State of Ohio Environmental Protection Agency

**Re: Construction Storm Water Inspection at Village at Hannah Farms
Franklin County
Permit Number: 4GC01921*AG**

Figure 1: Silt fence needs to be installed.

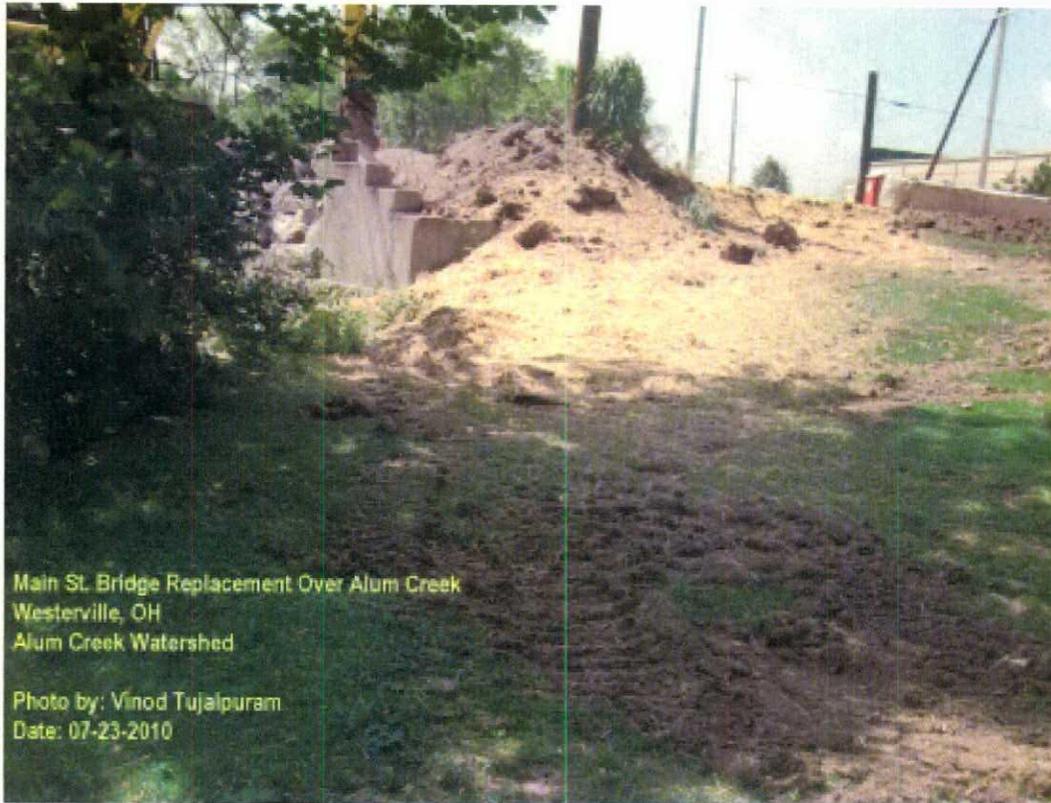
- During the site investigation, our staff found a lack of sediment and erosion controls along Clark State Road (Figure 1).
- Sediment controls for this project must be implemented in accordance with the General Storm Water Permit. Silt fencing must be implemented along the contour and control areas where sheet flow is present. The silt fence must be trenched in otherwise proper reinstallation will be required.
